UNITED STATES PATENT AND TRADEMARK OFFICE

APPLICATION NO.	FILING DATE	FIRST NAMED INVENTOR	ATTORNEY DOCKET NO.	CONFIRMATION NO.
10/803,282	03/18/2004	Scott A. Wojan	WOJ-100-A	5647

Office Action Summary

DETAILED ACTION

Chapman attachment # 1
(10803282, 03/24/05)

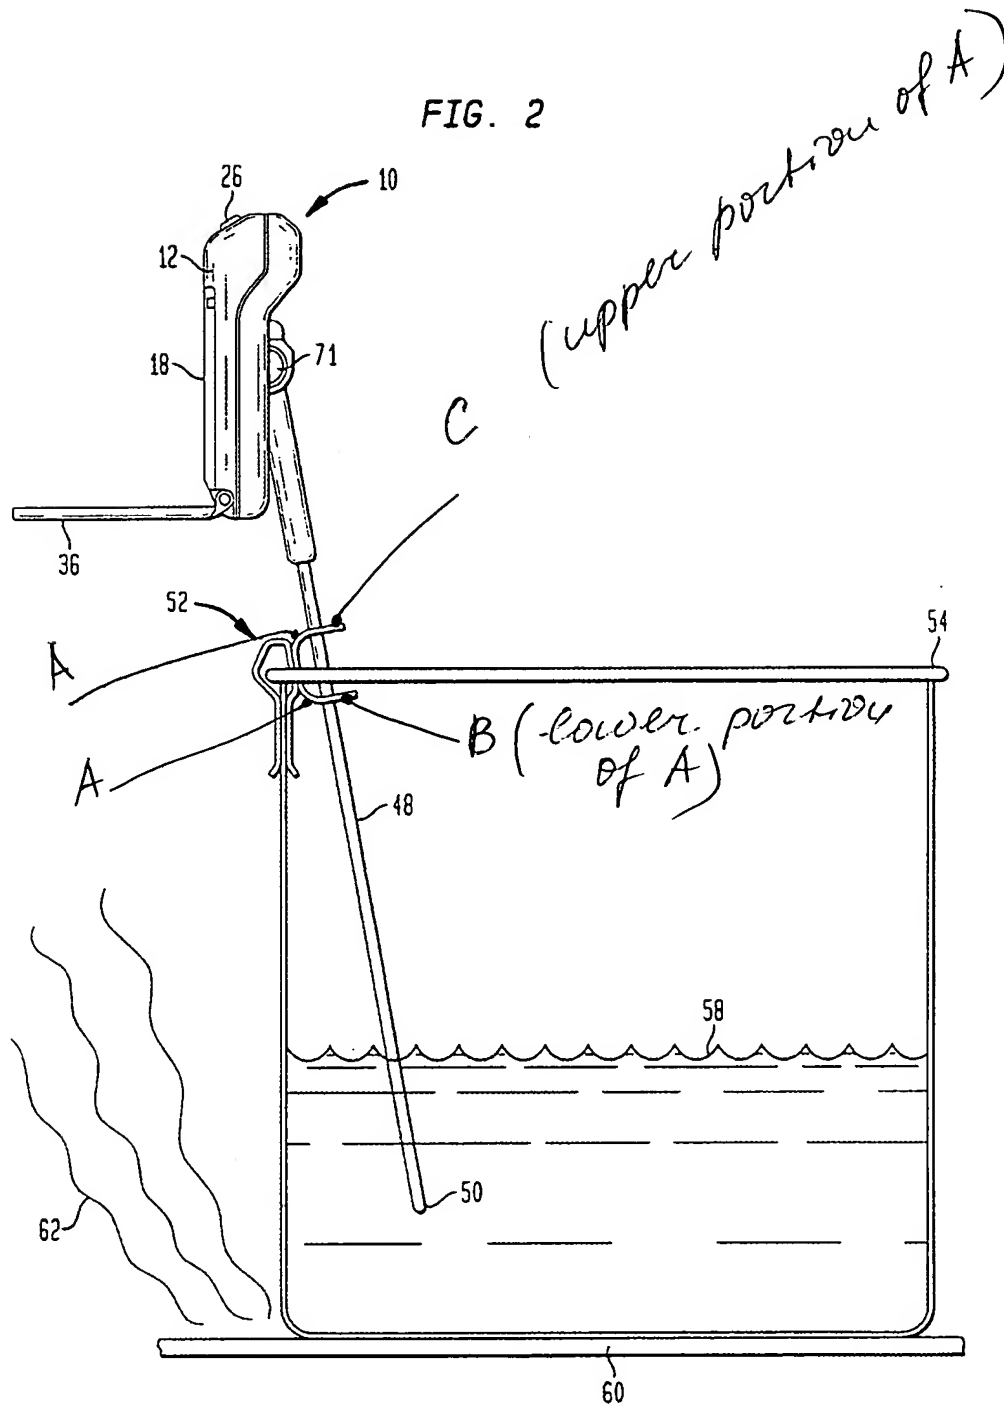
Chapman discloses a device in the field of applicant's endeavor comprising all the limitations of claim 31, including a housing 10, a control device (circuit) within the housing, a temperature probe 48, a display 18, an audible (visual message/identifier) device operably connected to the control device (circuit), and a support member 52 having a substantially planar radially extending outward from the probe portion A having a lower portion B positioned away from a housing 10; and an upper portion C positioned closer to the housing 10. The support member is engageable with a rim of a vessel, as shown in Fig. 2. (The numerals A-C have been added by the Examiner, see attachment # 1 to the Office action).

attachment # 2
(10803 282, 03/21/05)

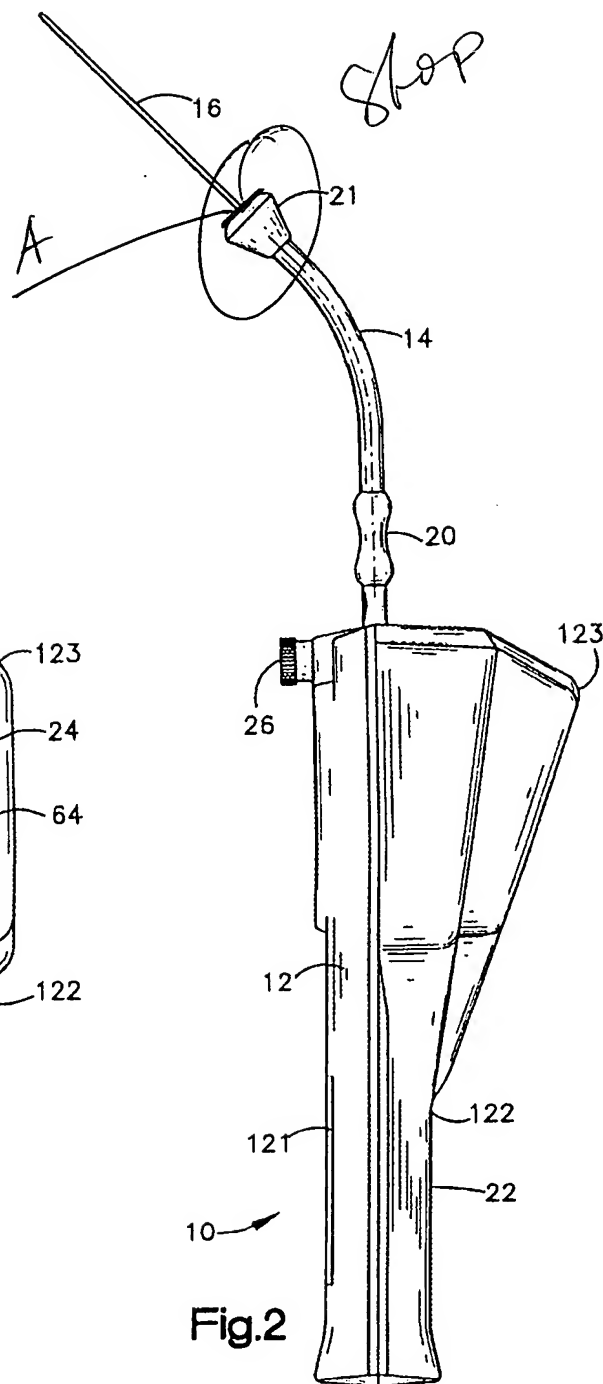
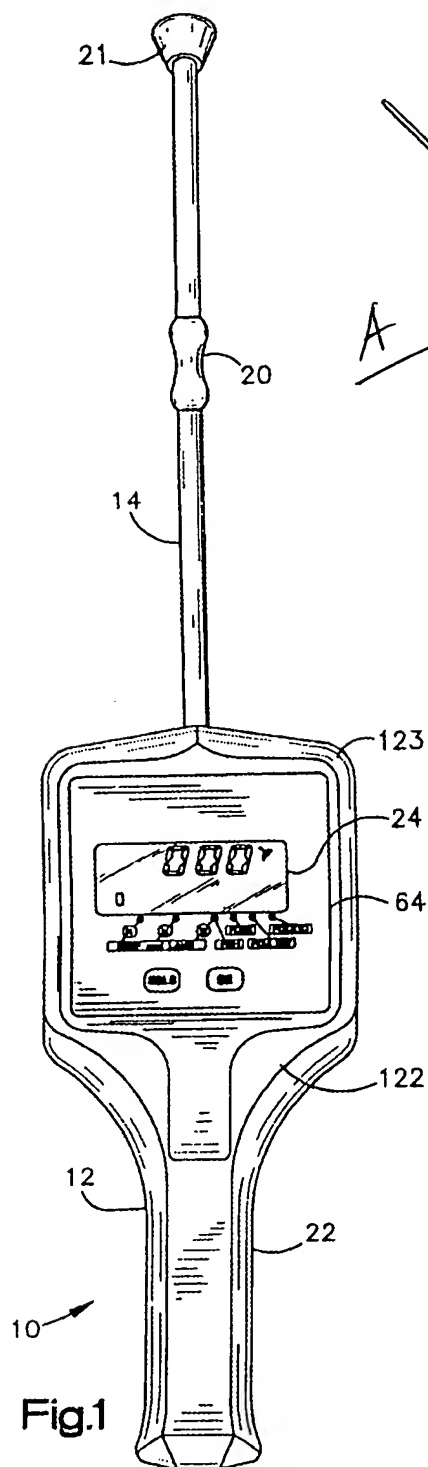
The device comprises a support member 21 attached to the temperature probe containing the infrared temperature sensor, the support member 21 having substantially planar portion A extending outward radially, as shown in Fig. 2. The support member 21 substantially coincides with the longitudinal axis of the temperature probe 14.

(The numeral A has been added by the Examiner, see attachment # 2 to the Office action).

attachment #3
(10803282, 03/21/05)

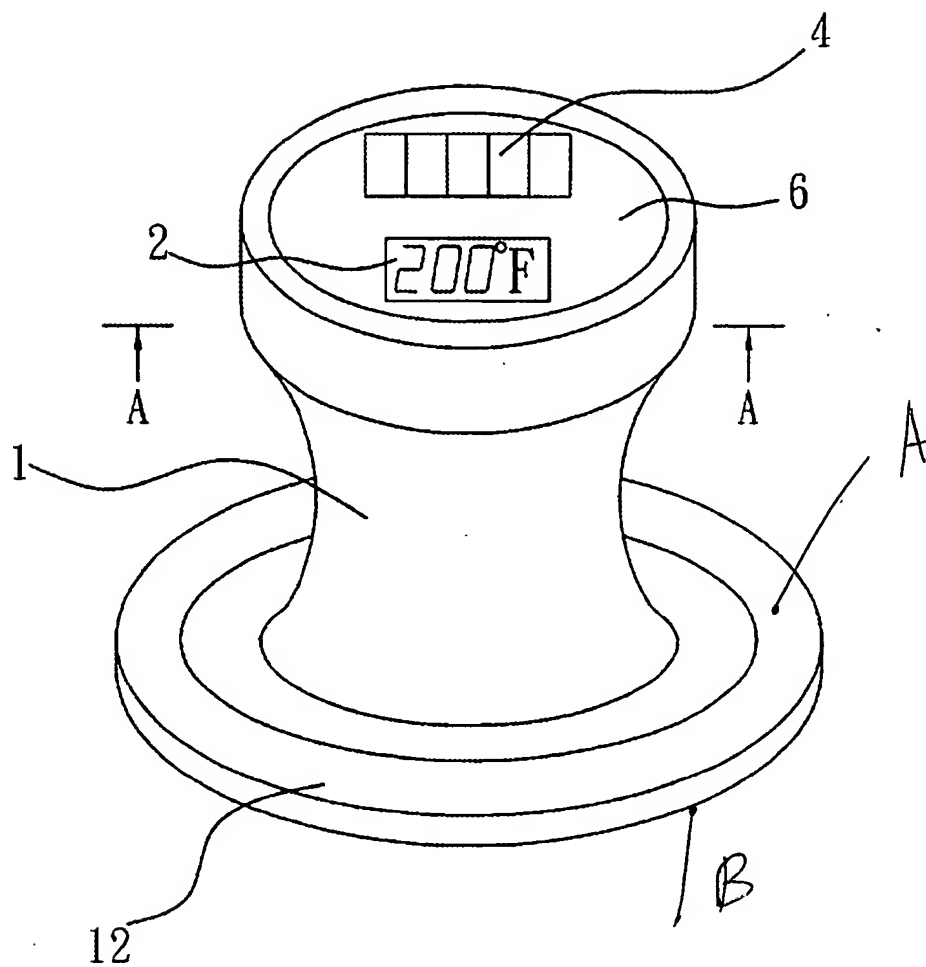
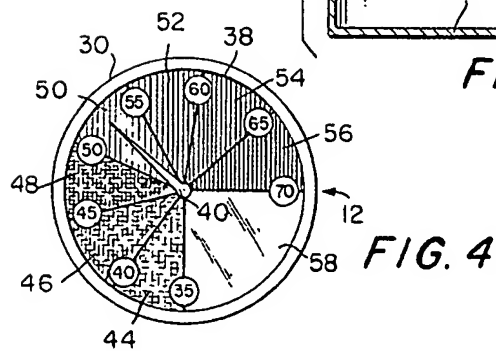
For claim 9: the substantially planar portion 12 of the support member 1 has an upper surface A positioned toward a housing (including display 6), and a lower surface B comprising a portion 131 positioned away from the housing, the lower portion B is engageable with a surface where the food of interest is.

(The numerals A-B have been added by the Examiner, see attachment # 3 to the Office action).

Hofer attachment # 4
(10803282, 103/21/05)

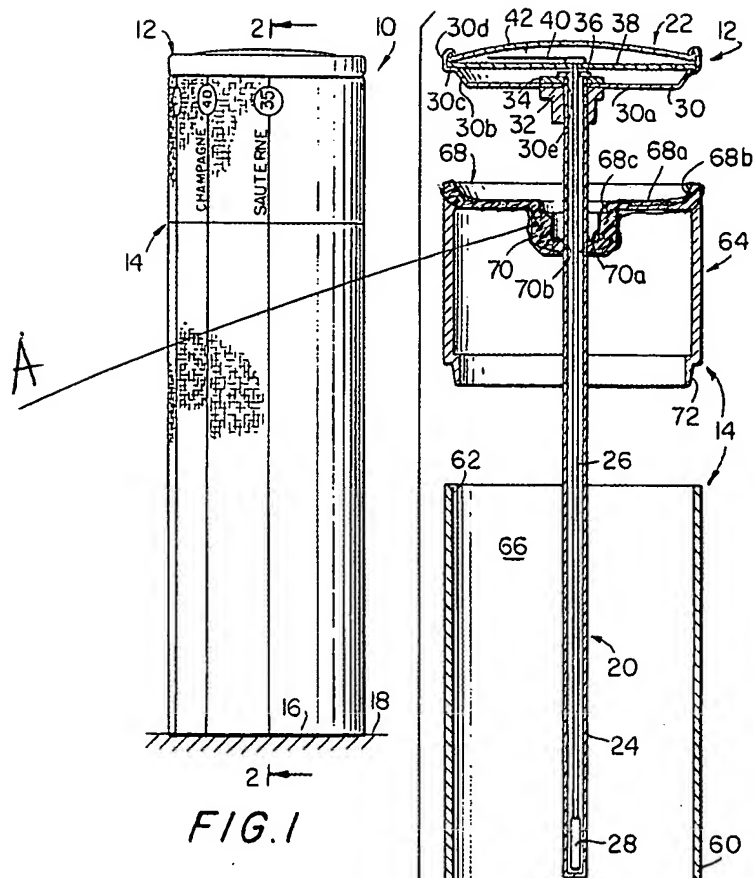
For claim 10: the support member 64 has portion A which has a substantially arcuate shape forming a concave upper surface and a convex lower surface, as shown in Fig. 2, and in the attachment # 4 to the Office action.

For claim 12: the longitudinal (vertical) axis of the infrared temperature sensor 20 intersects a centroid (central opening) B of the support member 64.

For claim 13: the support member 64 has a substantially disk-shaped portion C.

(The numeral A has been added by the Examiner, see attachment # 4 to the Office action).
